# **ORDINARY MEETING**

**EXTRACTIVE INDUSTRIES LICENCE APPLICATION  
AND  
ENVIRONMENTAL MANAGEMENT PLAN (EMP)**

**LOT 1 ON DEPOSITED PLAN 56443  
(927 CROOKED BROOK ROAD)  
SHIRE OF DARDANUP**

**Figure 2**

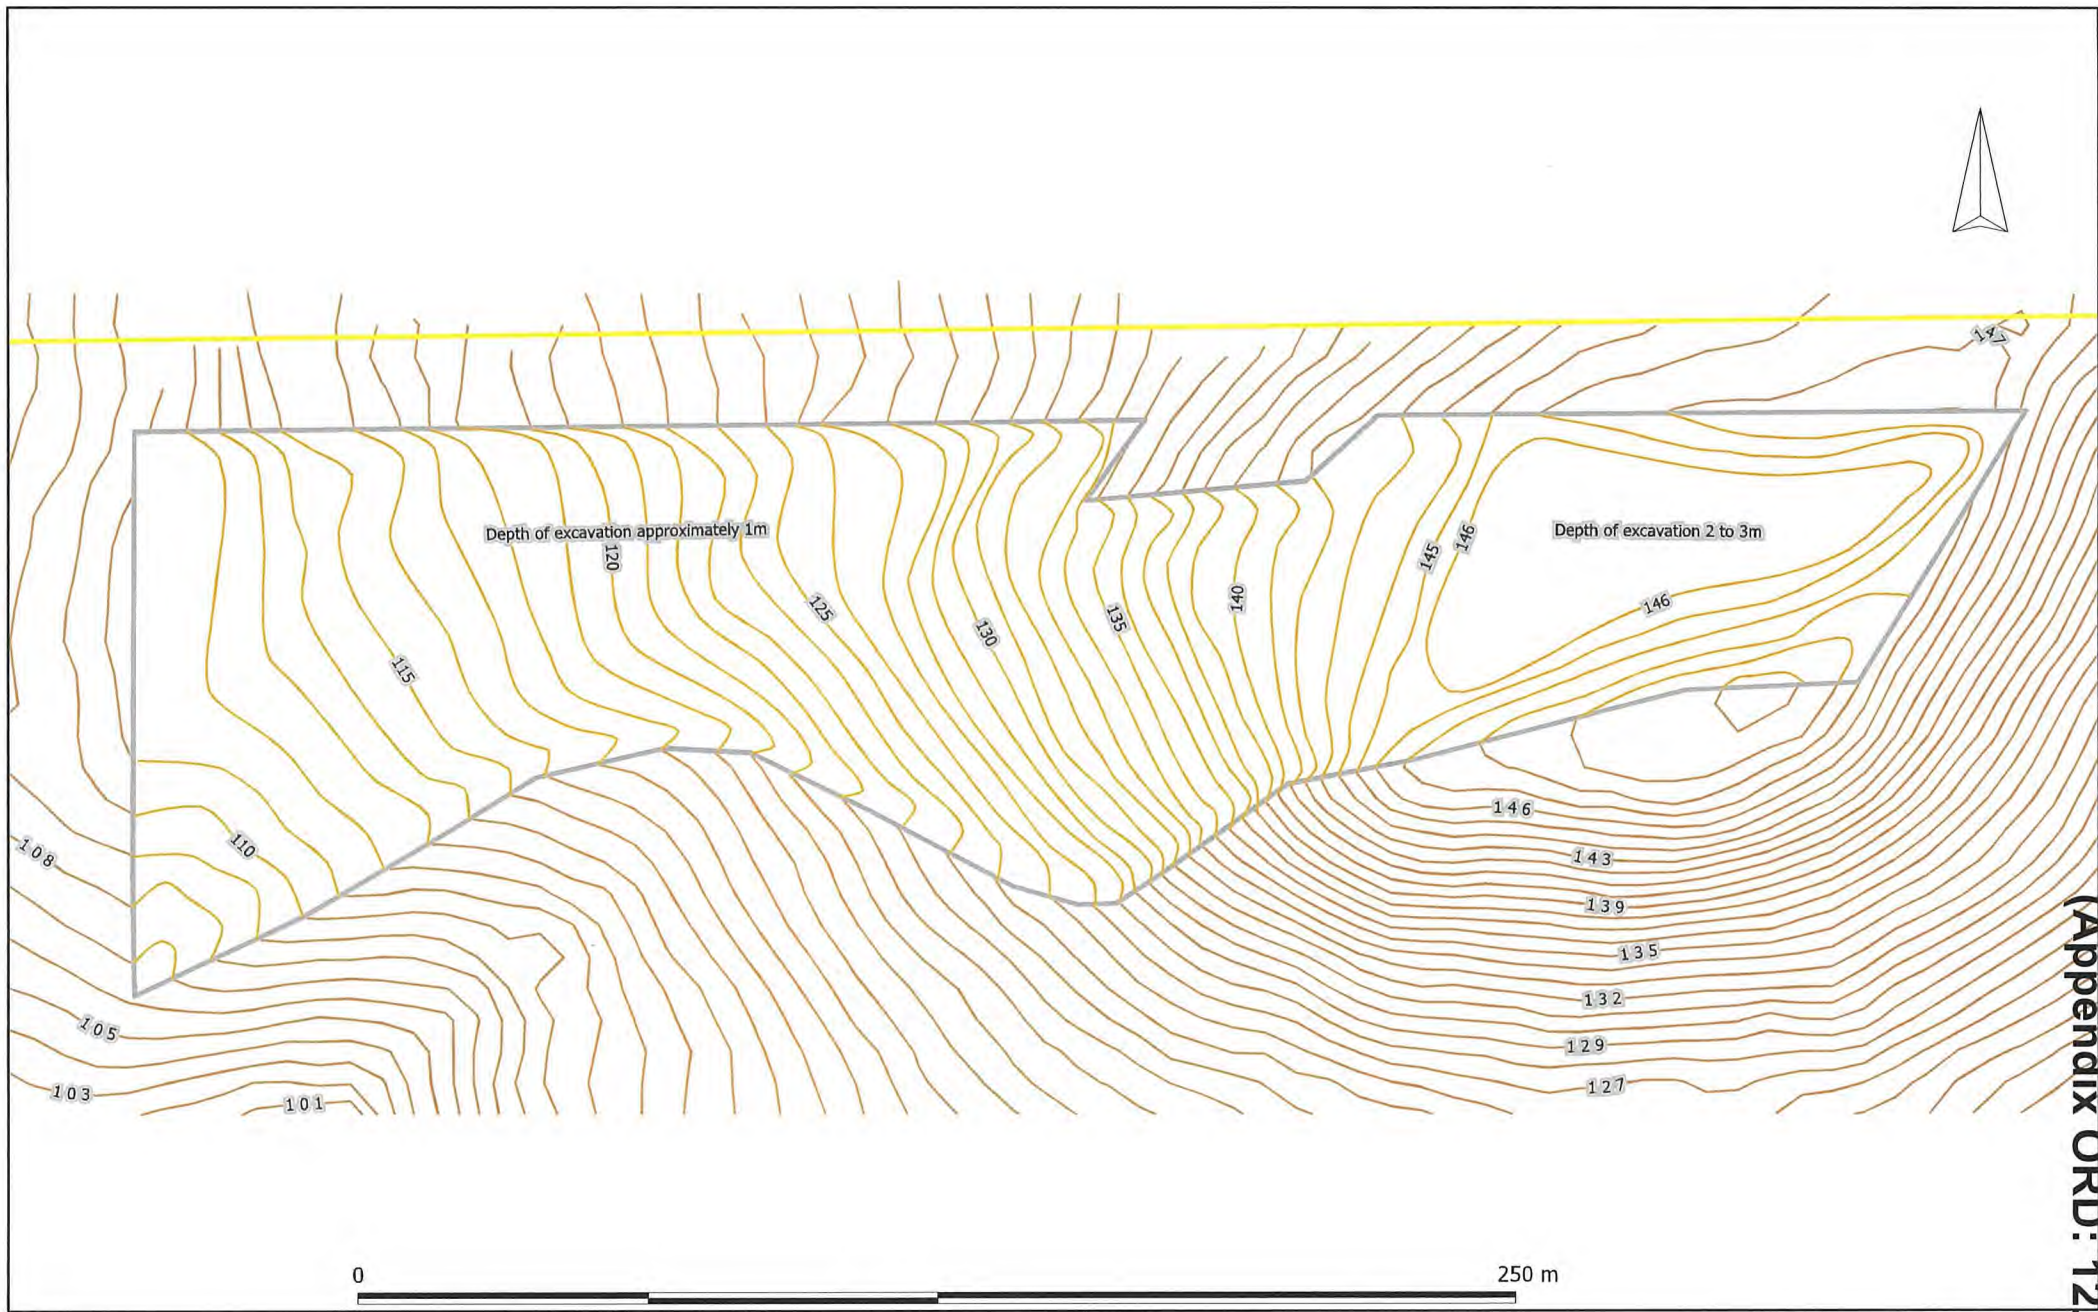
The Lundstrom Environmental Pty Ltd Site and Surrounds Map (Figure 2) depicts the location of the proposed access road, which is proposed to extend from Crooked Crook Road to the northern Lot 1 boundary and follows the Lot 1 northern boundary.

**Figure A**

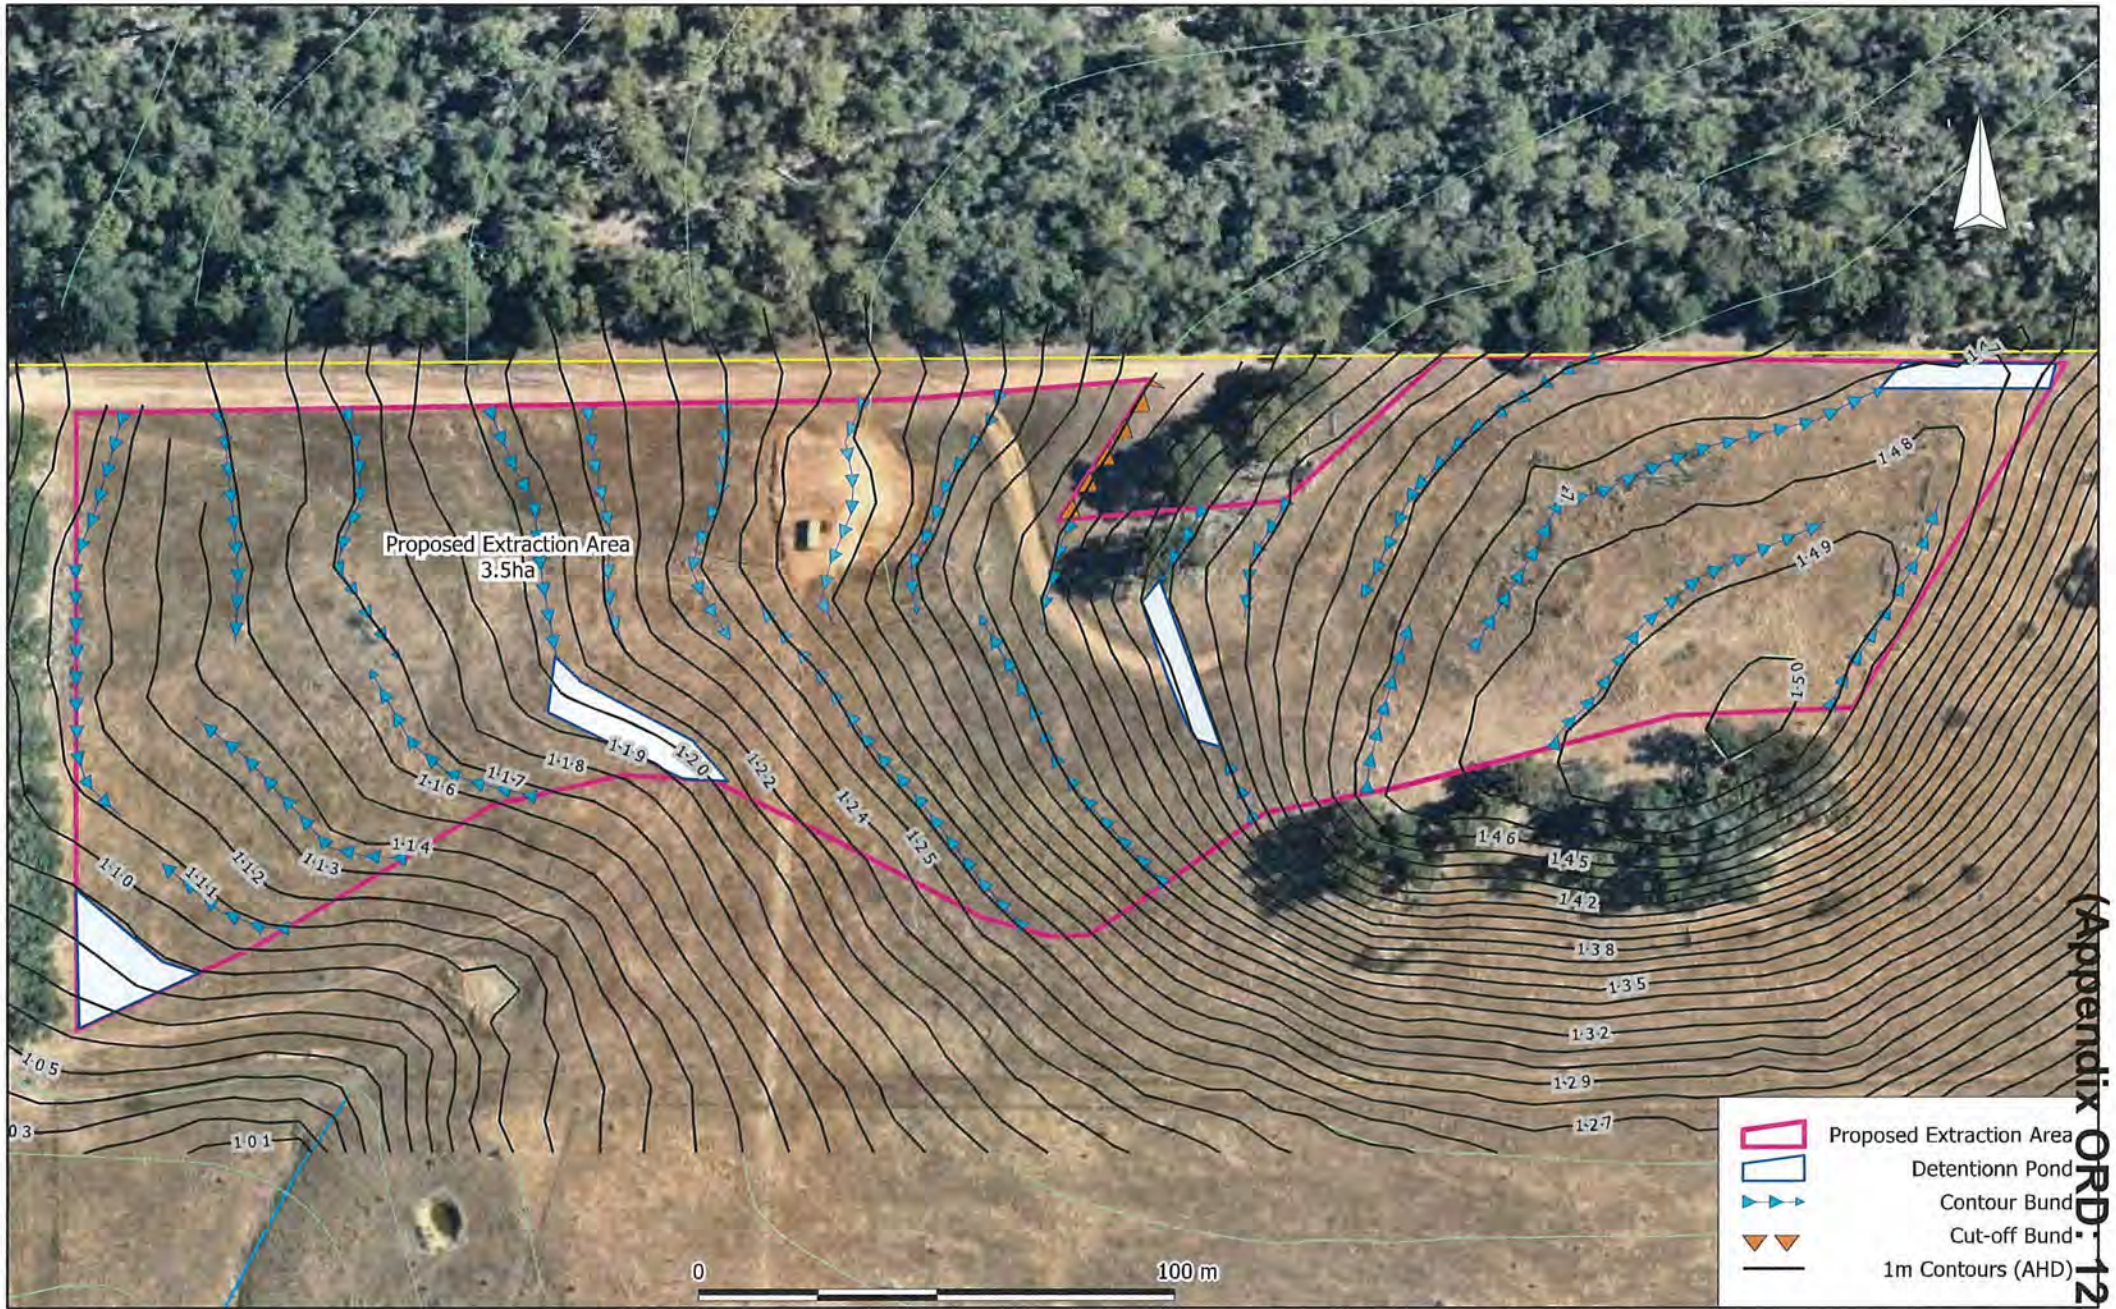
The Lundstrom Environmental Consultants Pty Ltd Water Management Plan (Figure A) depicts proposed contour bunds and detention ponds associated with the proposed extraction works.
